Content, Impact and Cause Analysis of Input Data Errors in Seismic Safety Evaluation Reports for Hamaoka Nuclear Power Station Reactors No. 3, 4 and 5 (Outline)

Seismic response analysis model of Unit No. 5 seawater heat exchanger building (Vertical direction)

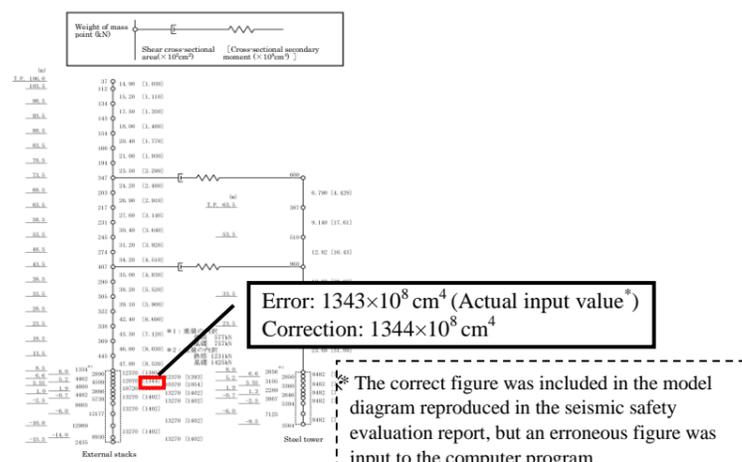
In three separate cases, figures for the axial springs, part of the data for analysis of vertical seismic response in the Unit No. 5 seawater heat exchanger building, which should have been input based on the 1999 edition of the Standard for Structural Calculation of Reinforced Concrete Structures ("RC Standard" below), were instead input based on the 1991 edition.

- While the results of the analysis using the correct data indicated that some corrections were necessary in the report, the error had no impact on the evaluation of the seismic safety of the reactor facilities.

- Corrections were made based on analysis models formulated during the design process with reference to the latest standards, etc., and these were employed in analyses for the evaluation of seismic safety. The analysis models formulated at the time of design (around July 1998) were produced using specifications (weight, axial spring, and vertical spring of ground) based on the 1991 RC Standard. However, at the time of the analysis (January 2007), the RC Standard had been revised in 1999, making correction of the specifications necessary.

- At the time of the analysis, in-house rules had not been established specifying the formulation of documents clearly setting out the bases for input and providing methods for verifying correct input of input data. Because of this, the members of staff responsible for the analysis brought up design data on the screen and replaced figures calculated using 1991 RC Standard data with figures that they calculated on a calculator, one by one, using 1999 RC Standard data, without formulating materials documenting bases for input that indicated where corrections had been made. During this process, the values for the axial springs were overlooked and not corrected.

- In addition, following correction of the data, neither the members of staff responsible for conducting the analysis nor any other members of staff verified whether the data had been appropriately corrected, and the errors were therefore not discovered.

Schematic diagram of reactor building ceiling crane runway

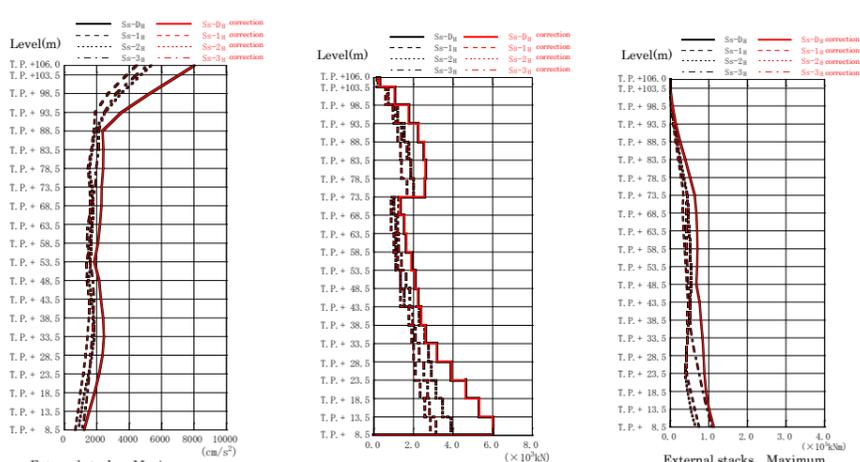
Due to a misunderstanding, an incorrect coefficient (0.4) was employed in calculating vertical load for the evaluation of the reactor building ceiling crane runway girders for Units No. 3 and 4 (one instance for each unit, for a total of two instances).

- Calculation of vertical load due to weight of runway girder
 (Error) $W \times \alpha_v \times 0.4 \rightarrow$ (Correction) $W \times \alpha_v \times 1.0$
 (W: Weight of runway girder; α_v : Vertical seismic intensity)

- While the results of the analysis using the correct data indicated that some corrections were necessary in the report, the error had no impact on the evaluation of the seismic safety of the reactor facilities.

- At the time of the analysis (around January 2007), the formulation of documents clearly setting out the bases for input was not stipulated in in-house rules. Because of this, while materials were formulated specifying the weight and other data employed in the analysis, the members of staff responsible for the analysis did not formulate materials documenting the bases for inputs that specified the method employed to calculate vertical loads from these data.

- Because of this, the staff members responsible for conducting the analysis mistakenly confused the calculation of the combination of loads in the same direction with the calculation of the combination of horizontal seismic force and vertical seismic force, and multiplied the weight of the runway girders by the coefficient employed in these calculations (0.4).

- In addition, the error was overlooked because neither the staff members responsible for conducting the analysis nor other staff members checked the method employed to calculate vertical loads.
